**PLANNING BOARD AGENDA**  
**MAY 24, 2023– 7:00 P.M.**

RE: Diamond Point Development  
4 Baldwin Place Road  
Town of Carmel  
TM#s: 86.10-1-2&3

In response to comments received from Director of Code Enforcement, Michael Carnazza, dated March 22, 2023, we offer the following responses:

In response to comments received from Town Engineer Richard Franzetti, PE, dated March 20, 2022, we offer the following responses:

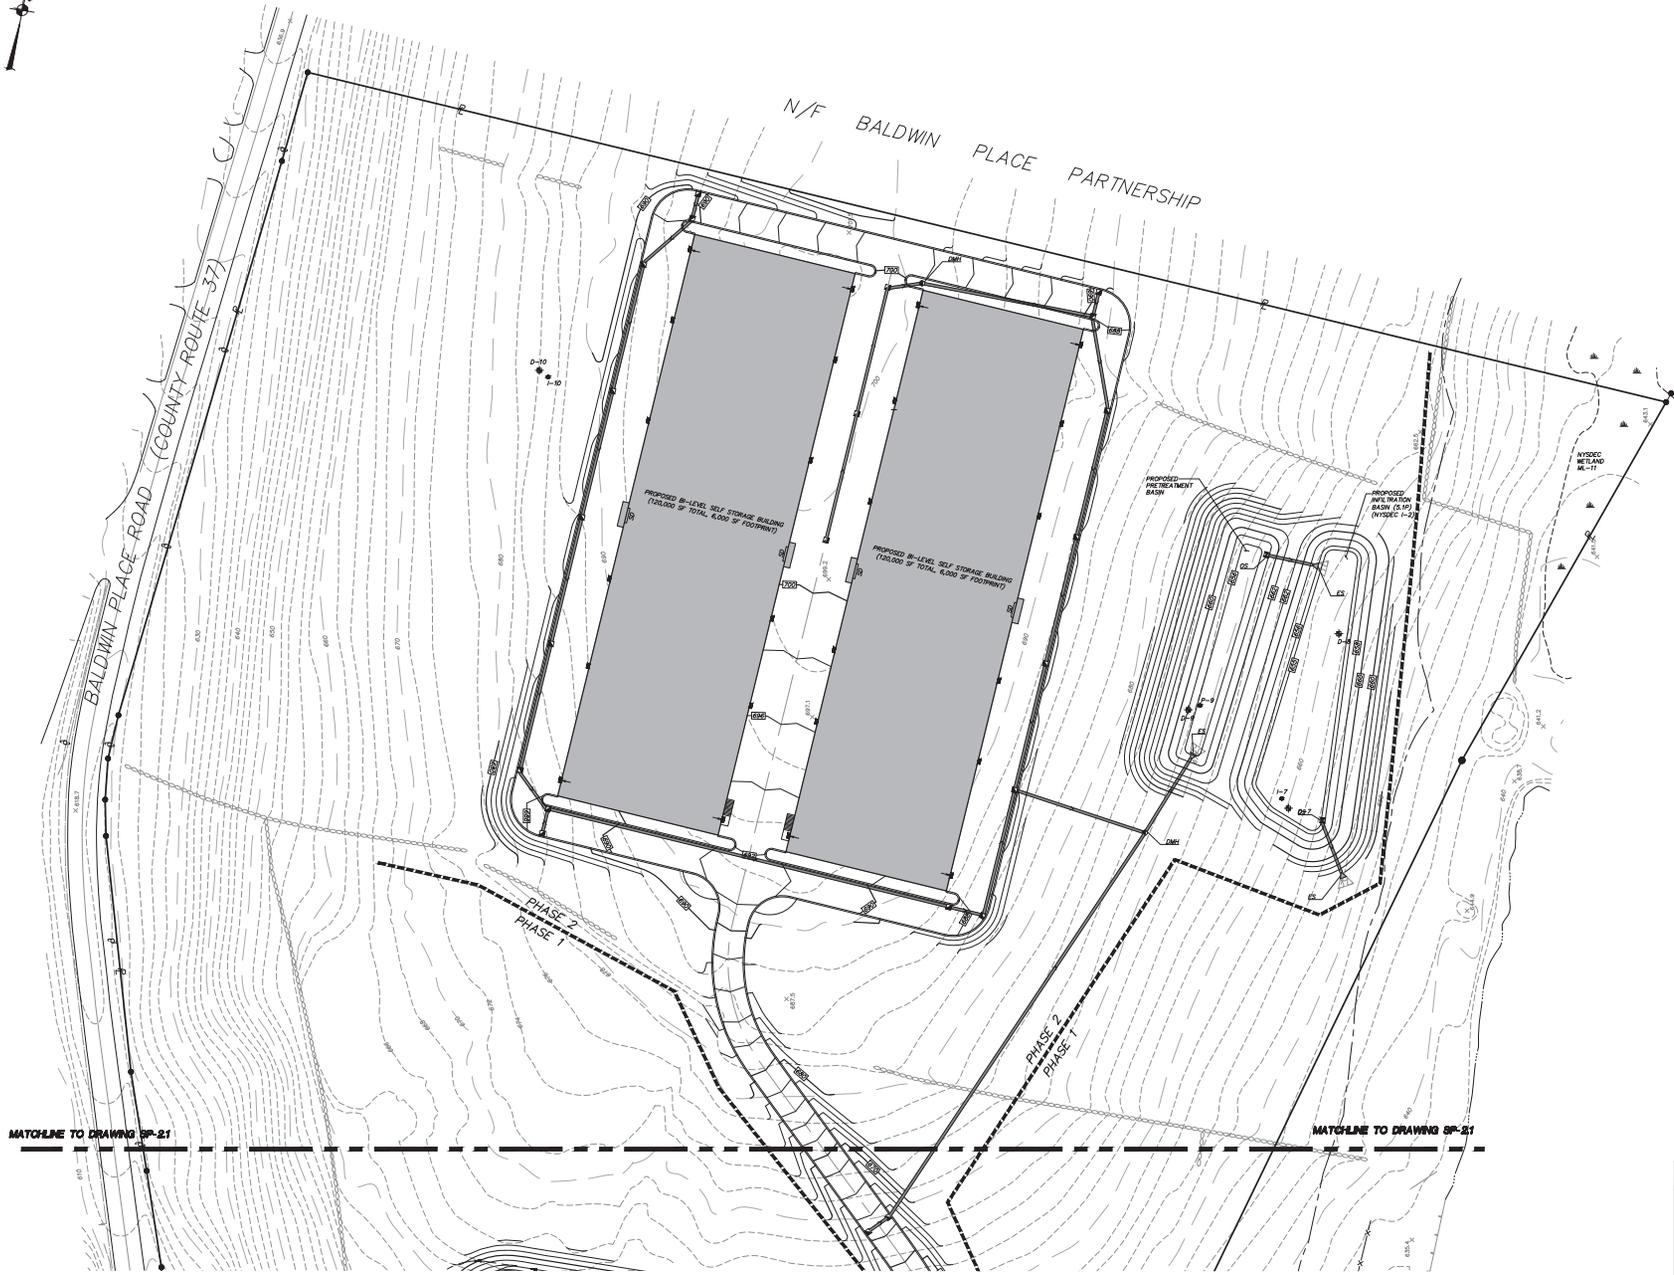
- c) Sight distances will be provided by the traffic engineer with a future submission.
  - d) Slopes at the driveway entrances have been provided on drawing SP-2.1.

11. A SWPPP was provided. Per the Town Engineer, it is under review. A revised SWPPP is enclosed herewith.
  12. Utilities are shown on drawing SP-2.1 and SP-2.2. Details thereto are shown on drawing D-3.
